Addendum #3

Date: July 2, 2015
Project: Campus Lighting Improvement
Contract: FD-15-013

R E V I S I O N S						PROJECT TITLE: CAMPUS LIGHTING IMPROVEMENTS					
REV.	REVISIONS	RVSD	CHCKD	APRVD	DATE	PARTIAL SITE PLANS – PARKING LOT LIGHTING–P1, P3, P4, P16, P18, P19, P25					
1	REVISED PER ADDENDUM #3 - 7/2/2015					SCALE		AS NOTED	DATE	REVISION NO.	0
						DRAWN BY		EML	05/08/15	E–101	
						CHECKED BY		DEDC	05/18/15		
						APPROVED BY		DEDC	05/18/15

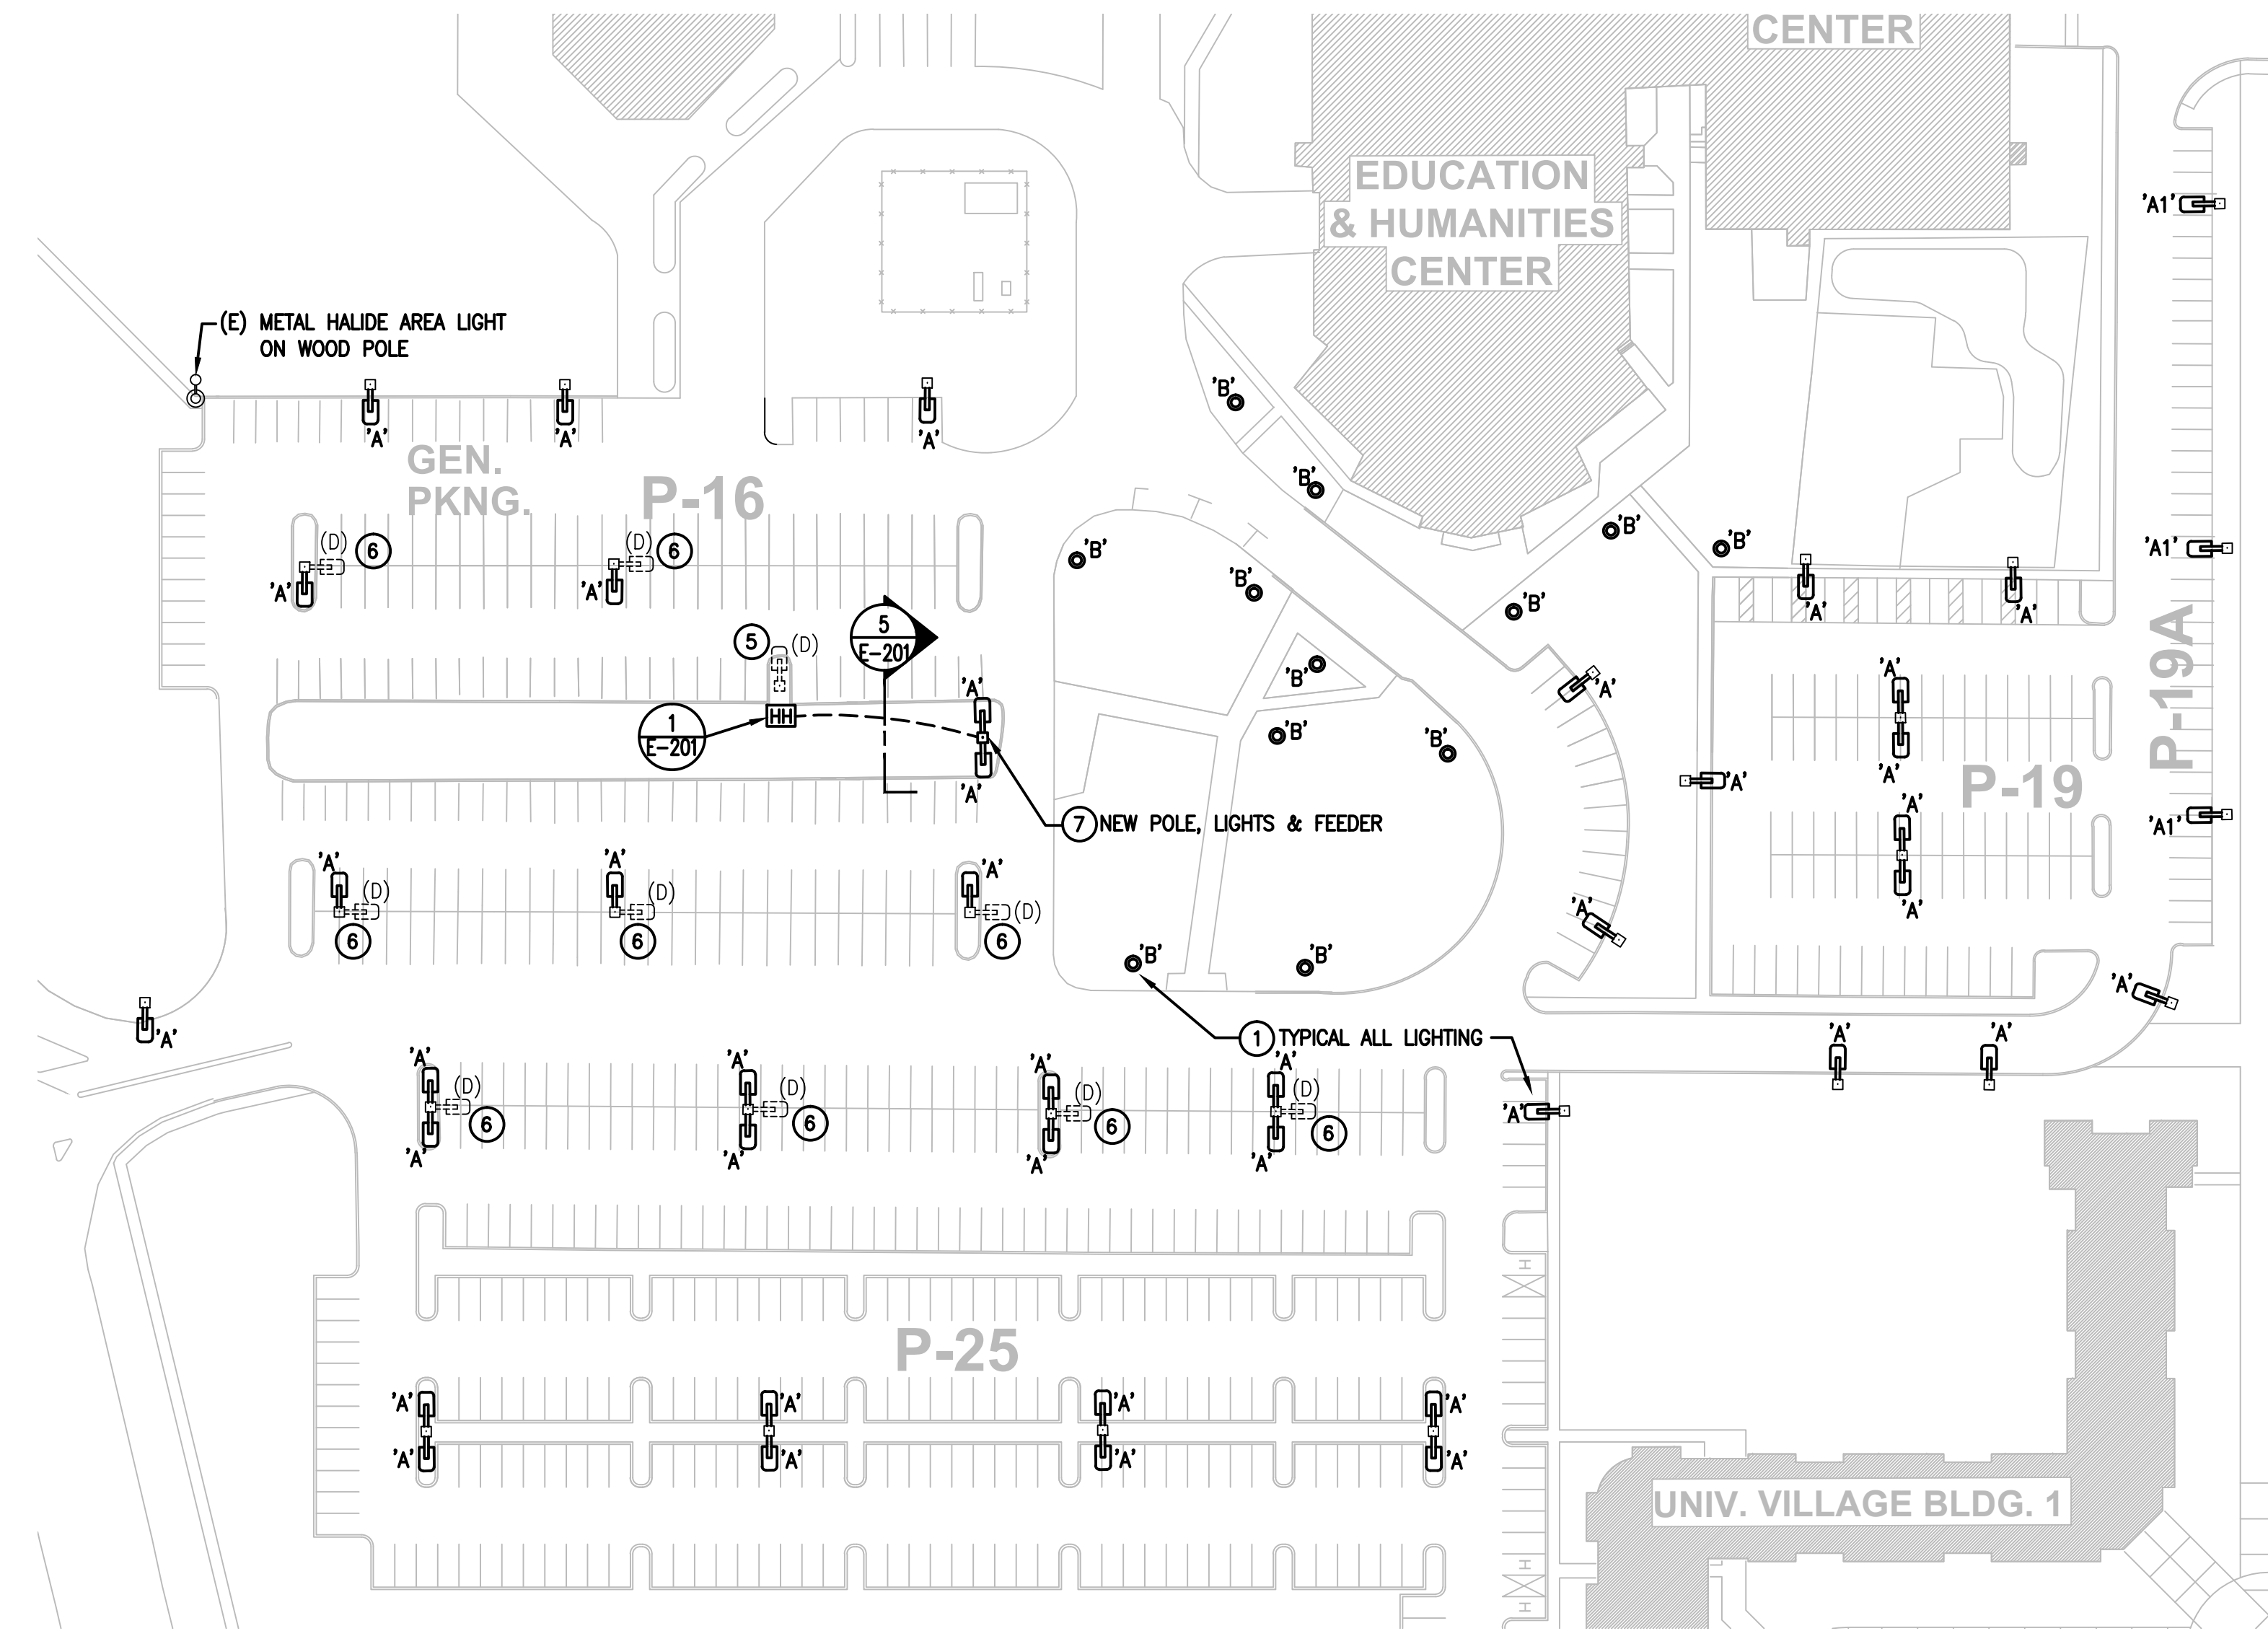
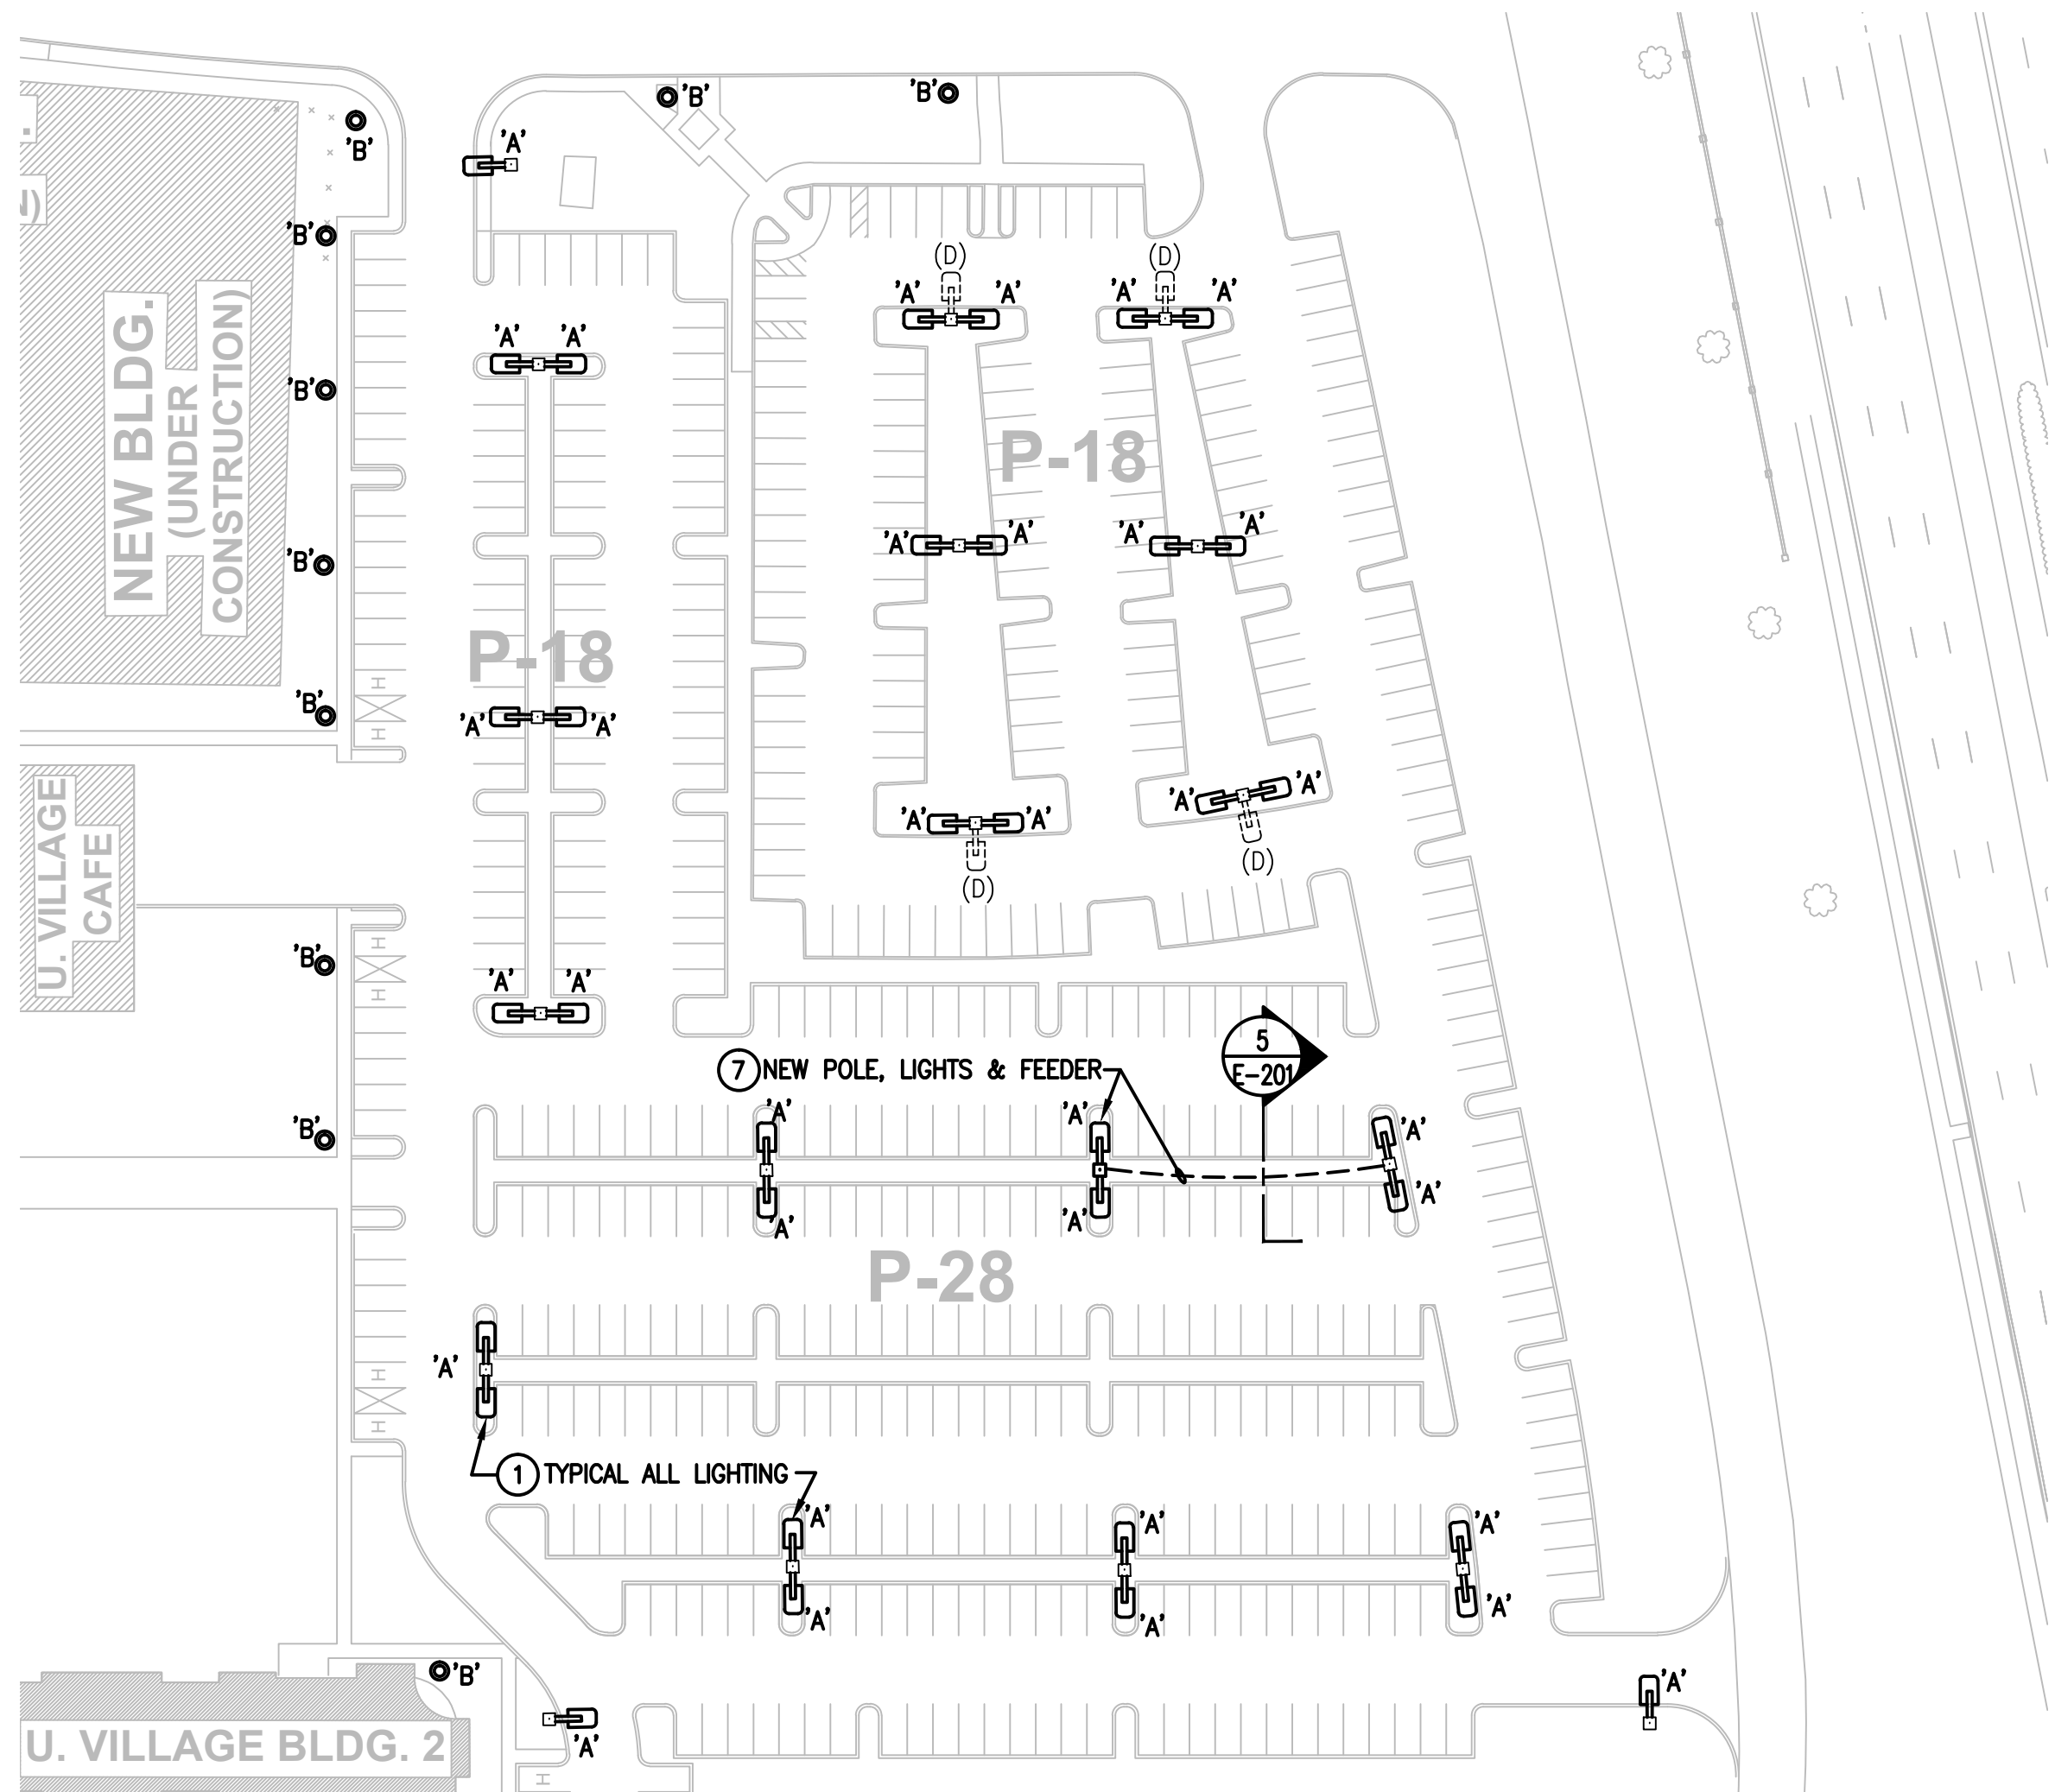
1. Drawing E-101 – Drawing has been reissued to clarify scope based on contractor questions.

Question: Drawing E101 at M.Evers Hall shows two new wall packs to use the existing circuit. Can the new conduit be surface mount on the outside of the building? If not will it have to ran inside the building are there drop ceiling for route for the new wiring?

Question: At the tennis court are they show a new type fixture and pole. Need location where it be will fed from.

Answer: The new conduit can be surface mounted to the outside of the building. Conduit shall be galvanized rigid metal conduit, properly supported, and adequately fastened to the existing building construction.

Answer: Refer to attached drawing E-101 for source and diagrammatic conduit path. Install in accordance with detail 5/E-201.
